ADDENDUM NO. 3
TO THE CONTRACT DOCUMENTS
for the construction of the
NATOMAS MUTUAL WATER COMPANY
RIVERSIDE PUMPING PLANT REPLACEMENT

Date: April 26, 2022
Project No.: W8Y09800

The following changes, additions, and/or deletions are hereby made a part of the Contract Documents for the construction of the Natomas Mutual Water Company Riverside Pumping Plant Replacement, dated March 2022, as fully and completely as if the same were fully set forth therein:

DATE	MARCH 2022
PROJ	W8Y09800
DWG	900-SD-0006
SHEET	47 of 51

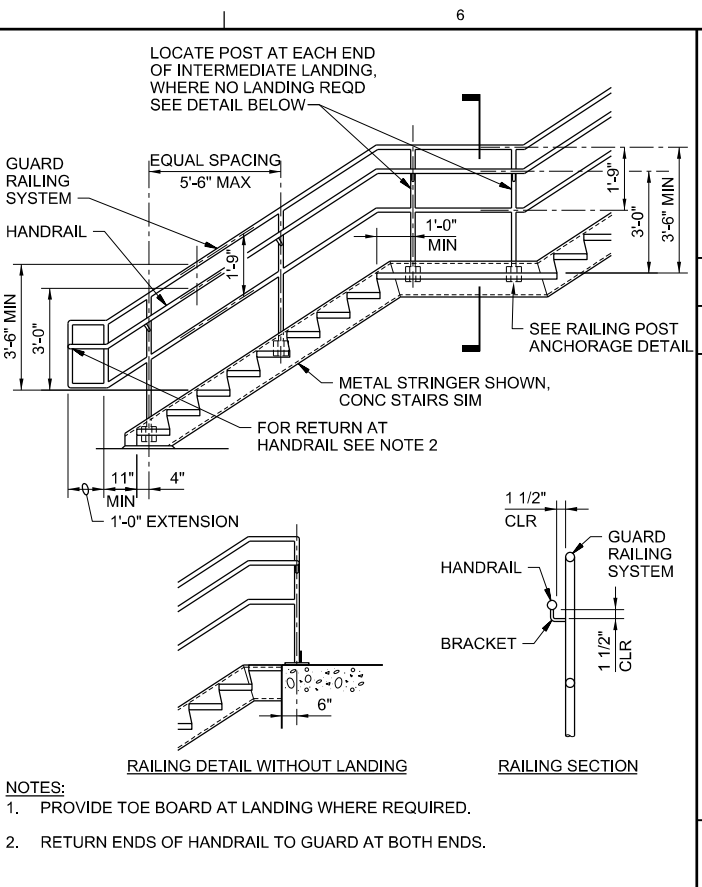
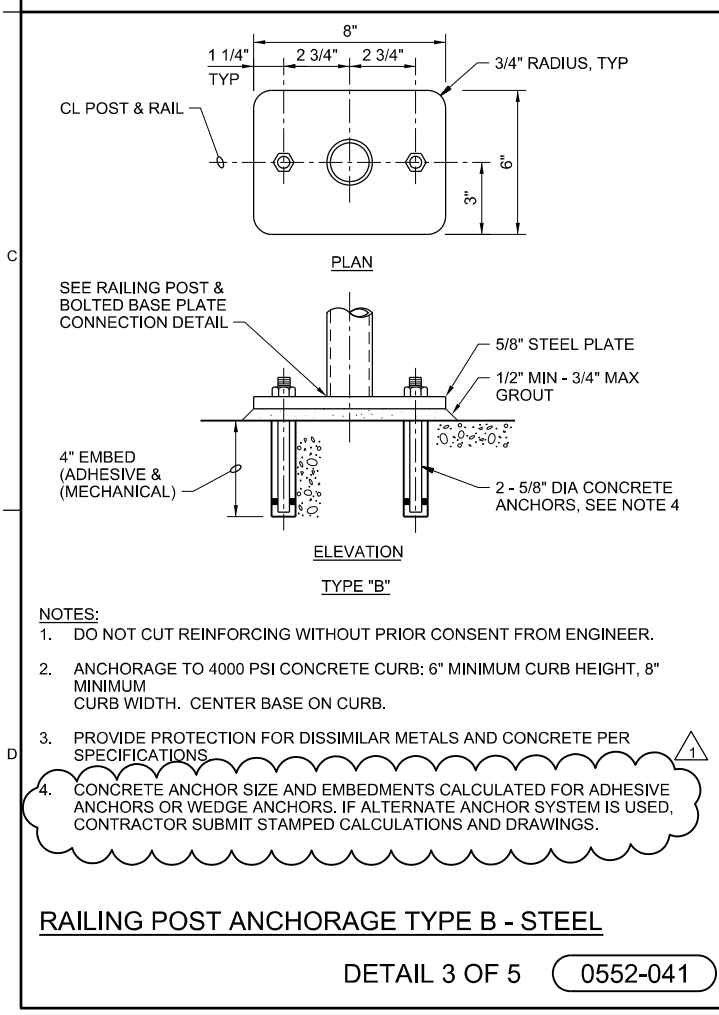
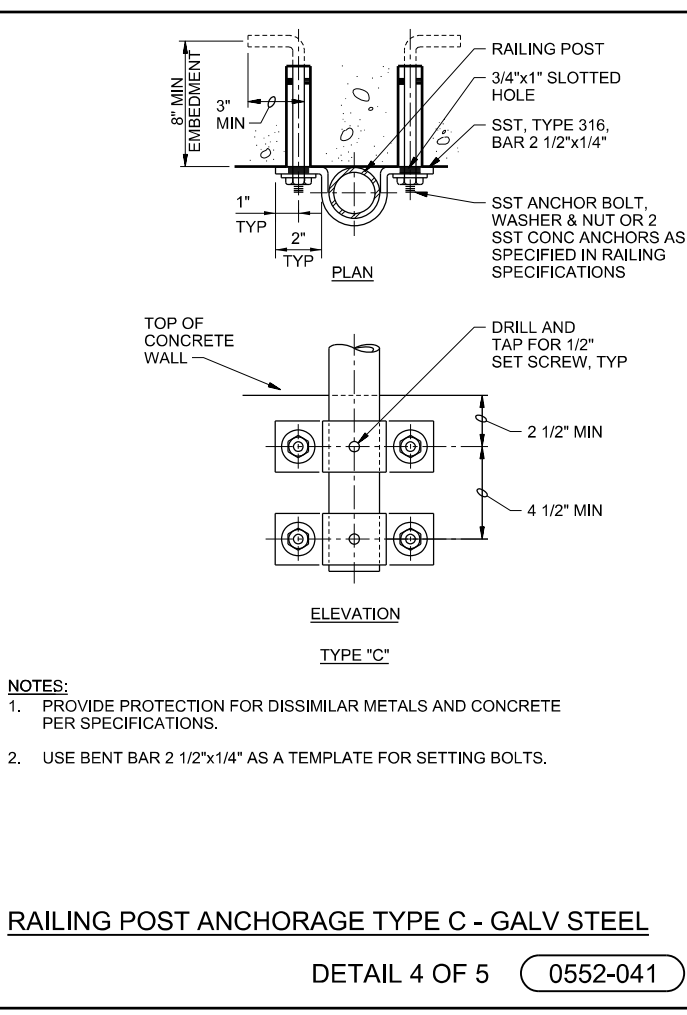
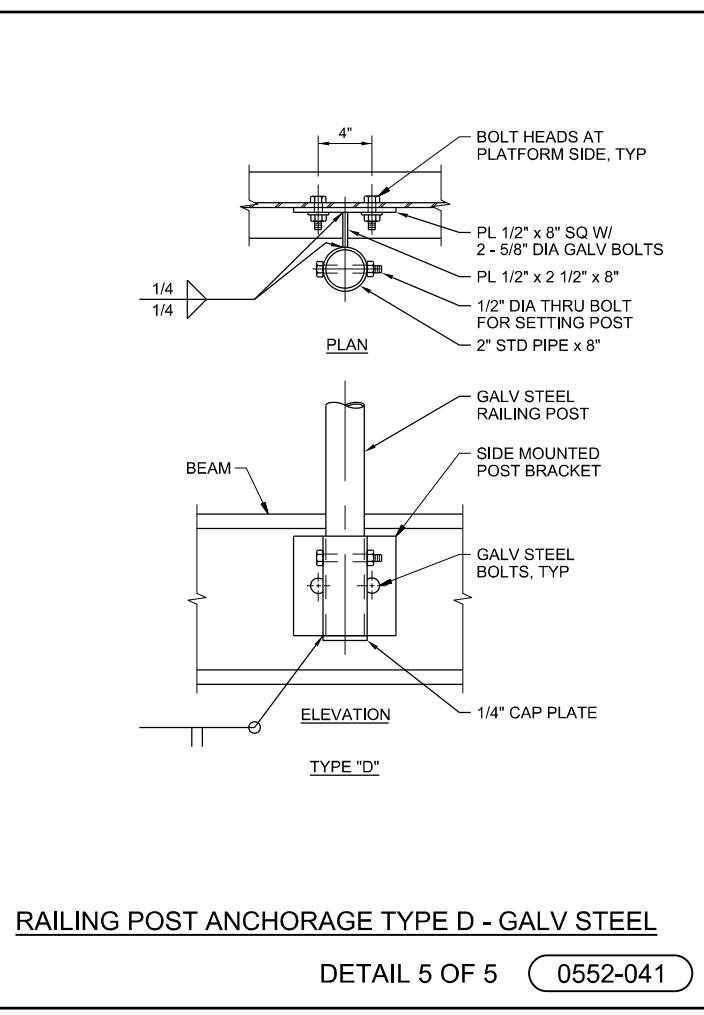
Question: Sheet 46 Detail 5 of 5 (0551-041) does not provide leg dimensions for the 3/16” steel bent plate. Detail 3 of 5 doesn’t indicate dimensions for the Steel angle attachment from the stairs to the concrete face. Please provide.

4. Drawing 900-SD-0006, STANDARD DETAILS, REPLACE entire Drawing with attached revised Drawing 900-SD-0006, STANDARD DETAILS.
5. SHEET NO. C-101, RADIO ROAD LIFT STATION RAILING: ADD new Drawing C-101, RADIO ROAD LIFT STATION RAILING.

Response: The 3/16” bent plate shown in DETAIL 5 of 5 would be fabricated to meet the minimum edge distance and entering and tightening clearance requirements of the ASCI Manual of Steel Construction as indicated in structural steel and metal fabrications note 3 on drawing 000-G-0006. At DETAIL 3 of 5, the top connection detail has a note to see the landing connection for notes not shown. The angle attachment is detailed in the landing connection.
